Notice of Addendum No.2

Invitation to Bid Title: Barcroft Elementary School HVAC Replacement Project

Invitation to Bid Number: 95FY23

Attachment B: Construction Laydown Areas

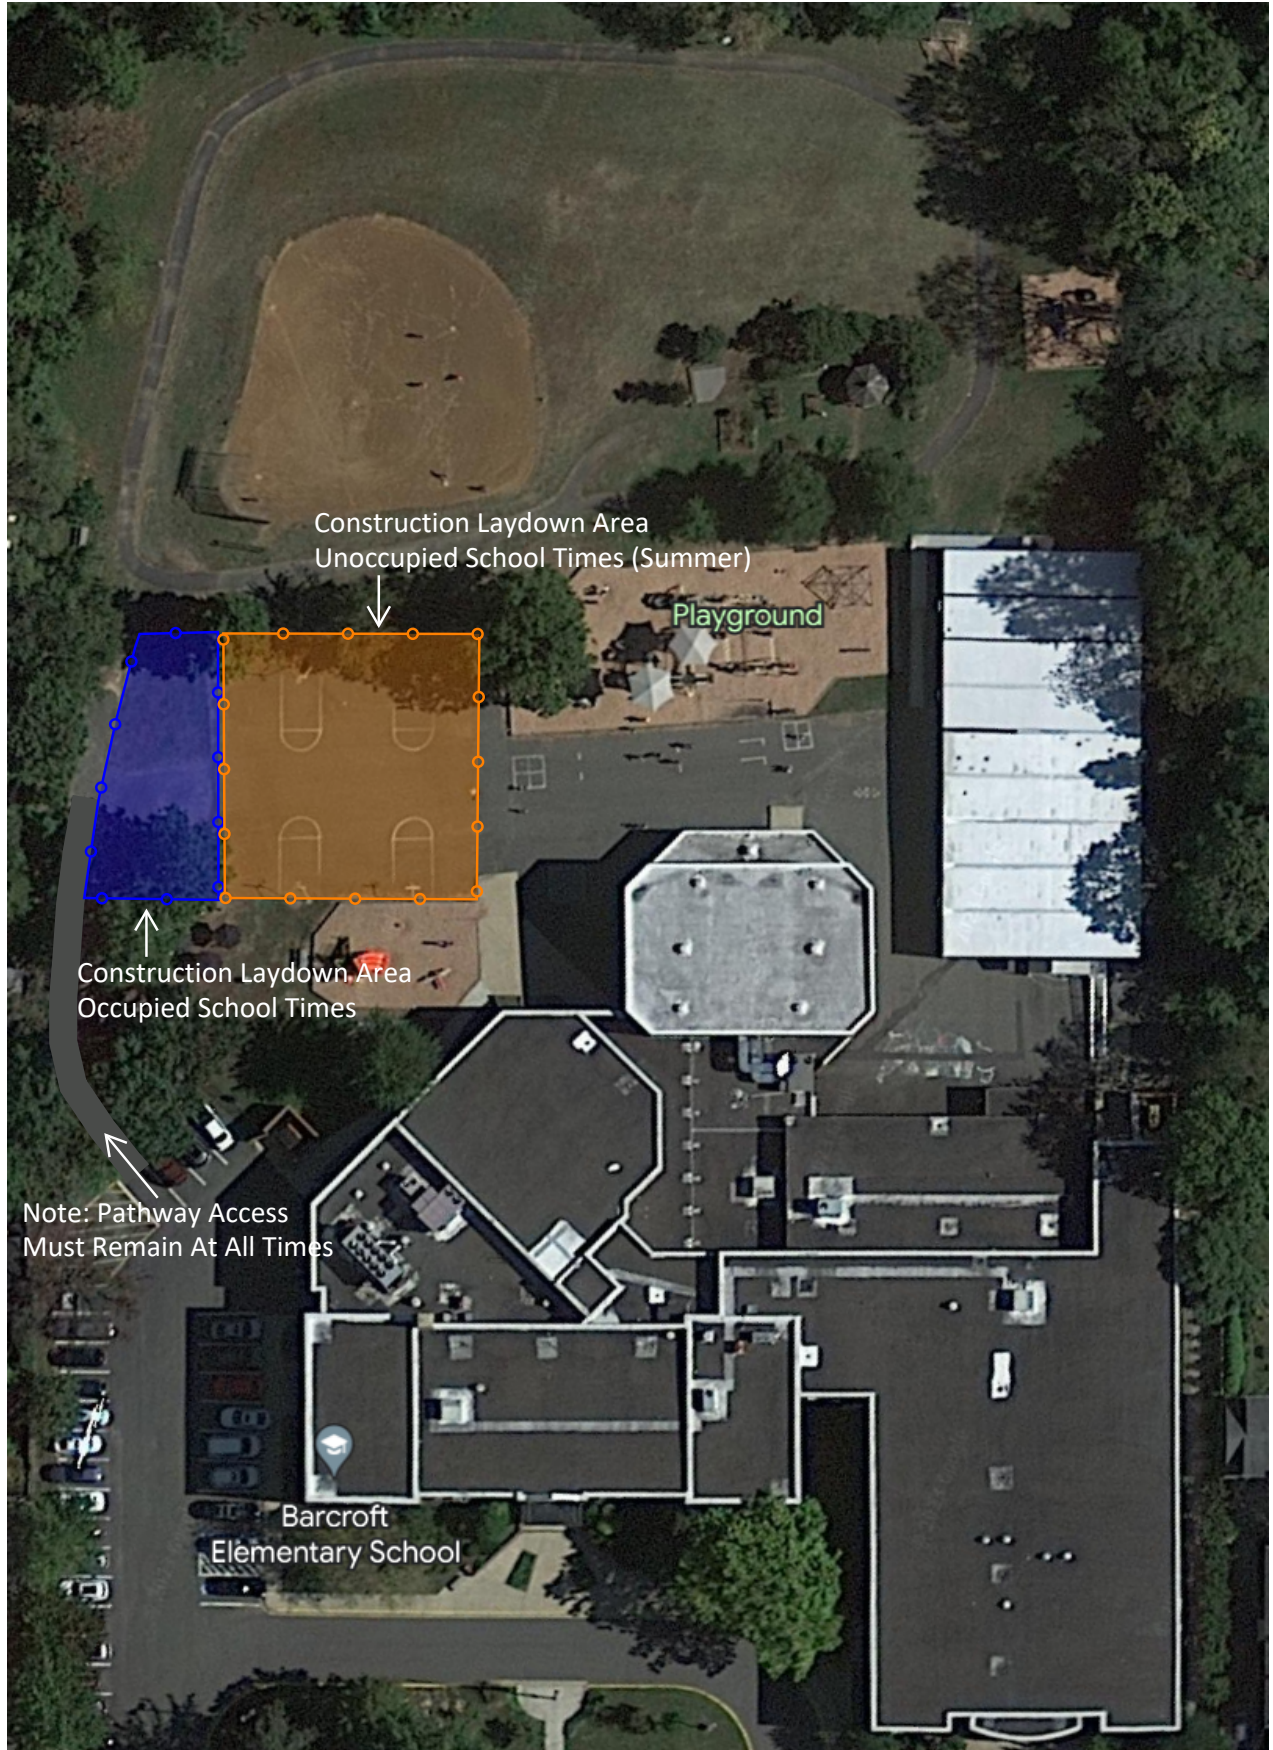
7	APS	Please confirm staging areas will be half of the basketball court and part of the field can we stage materials etc.	A sketch has been provided for informational purpose to define construction laydown areas that may be used by the contractor. The sketch defines areas that may be used during construction for school unoccupied (Summer) and occupied times (Fall, Winter, Spring).

A sketch has been provided for informational purpose to define construction laydown areas that may be used by the contractor. The sketch defines areas that may be used during construction for school unoccupied (Summer) and occupied times (Fall, Winter, Spring). These areas must be fenced to prevent public access when used.
